To: All U.S. and Canadian Volvo Retailers  
Subject: Service Action S89833

**SERVICE ACTION S89833 Replace Headliner Clip**

TITLE:  
**SERVICE ACTION S89833 Replace Headliner Clip**

<b>Title</b>	Replace headliner clip	<b>Page</b>	1 ( 3 )
<b>Action</b>	Service action	<b>Operation number:</b>	97186-2

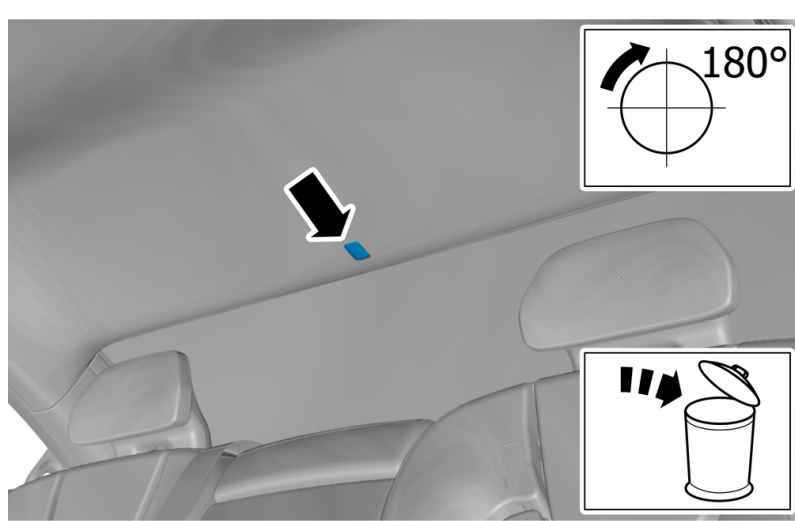
Remove the marked part.

**Installation**

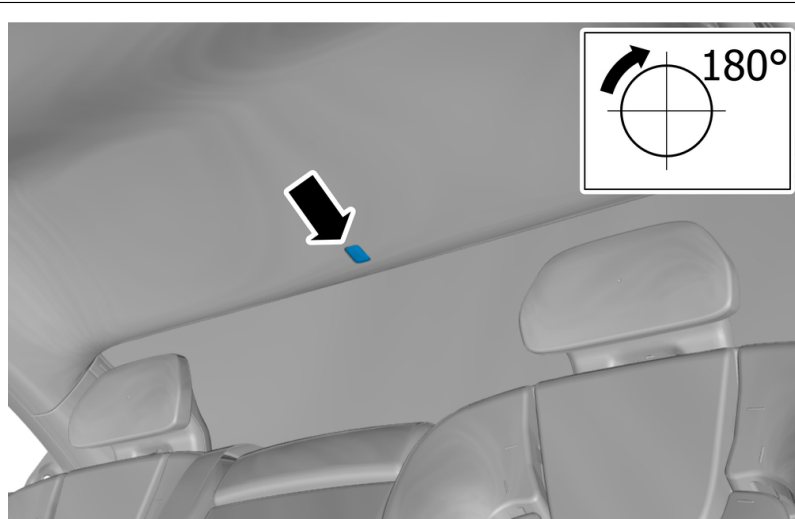
Install the clip.

**Note! Only use the specified material.**
